SUNDRY NOTICES AND REPORTS ON WELLS
Do not use this form for proposals to drill or to re-enter an abandoned well. Use form 3160-3 (APD) for such proposals.

EOG Resources requests an amendment to our APD for this well to reflect a change in casing.

EOG RESOURCES, INC.
DILLON 31 FED COM NO. 4H
REVISED 3/27/12

Dillon 31 Fed Com #4H
Pitchfork Ranch
Lea County, New Mexico
Revised 3/27/12
Proposed Wellbore

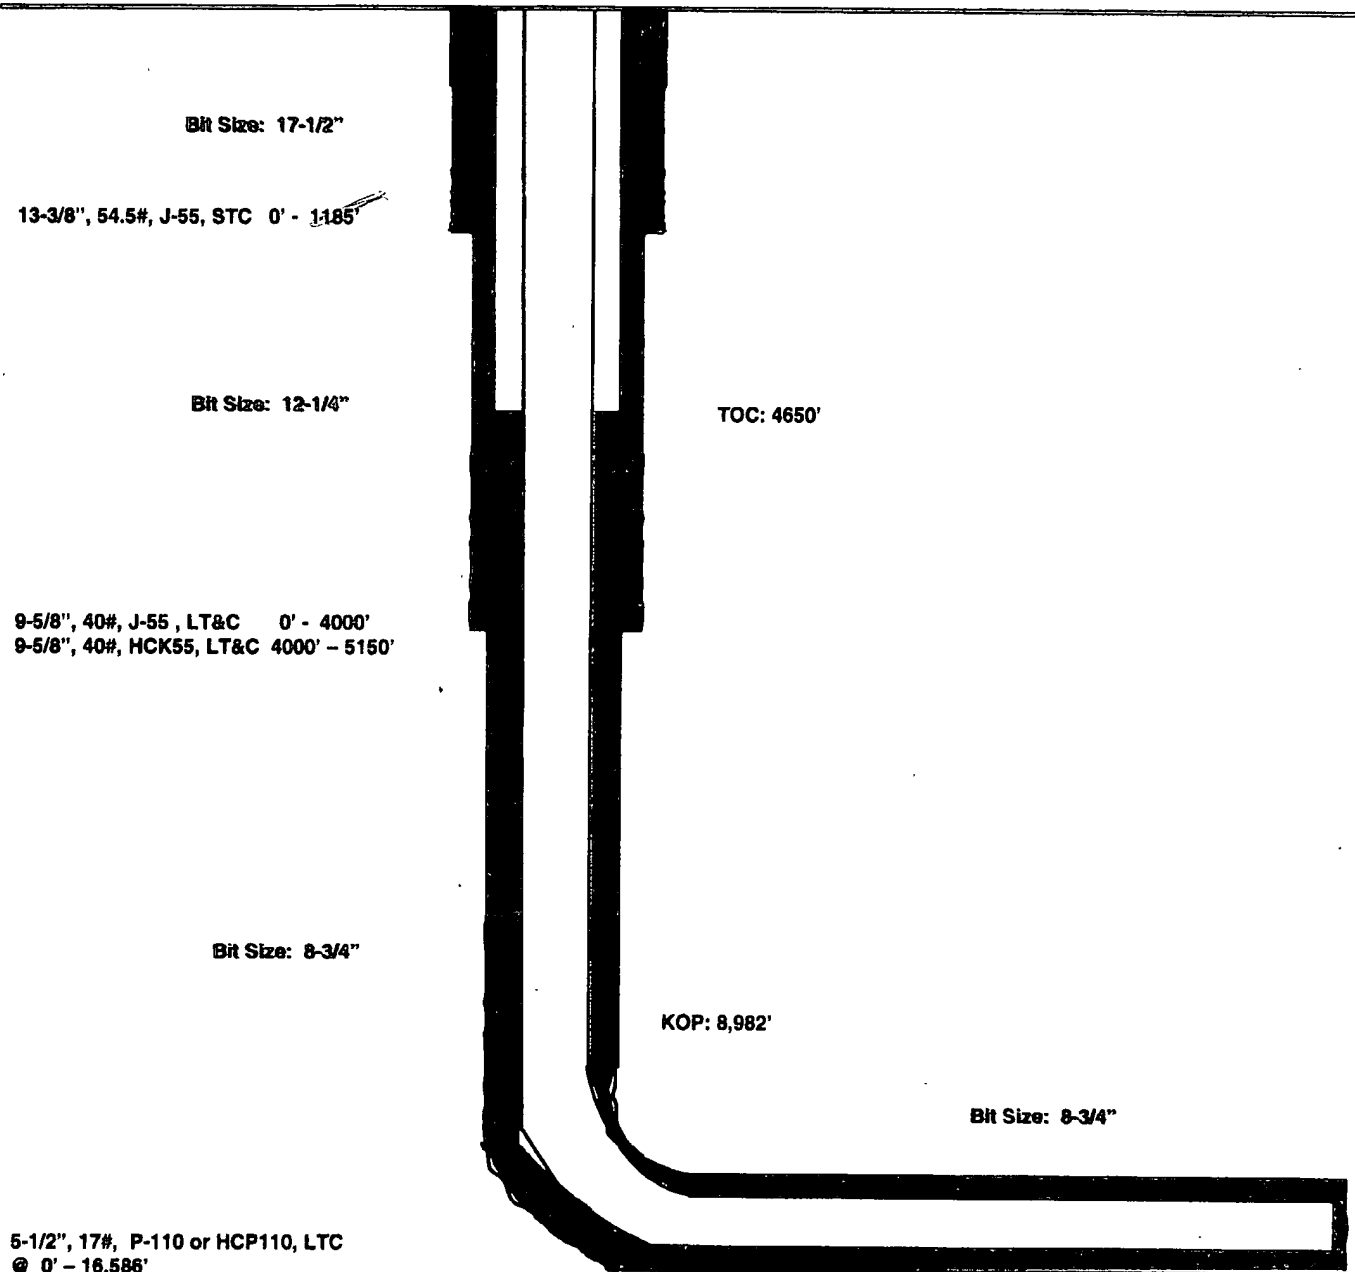
Casing changes are as follows:

From 11-3/4", 43#, H40 STC to 13-3/8", 54.5#, J55 STC
From 8-5/8", 32#, J55/HCK55 LTC to 9-5/8", 40#, J55/HCK55 LTC
From 5-1/2", 20#, HCP110 NSCC to 5-1/2", 17#, P110 or HCP110 LTC

Hole Size	¹²⁴⁵ Interval	Csg OD	Weight	Grade	Conn	DF _{min} Collapse	DF _{min} Burst	DF _{min} Tension
17.5"	0 - 1185'	13.375"	54.5#	J55	STC	1.125	1.25	1.60
12.25"	0 - 4000'	9.625"	40#	J55	LTC	1.125	1.25	1.60
12.25"	4000'-5150'	9.625"	40#	HCK55	LTC	1.125	1.25	1.60
8.75"	0'-16,586'	5.5"	17#	P110 or HCP110	LTC	1.125	1.25	1.60
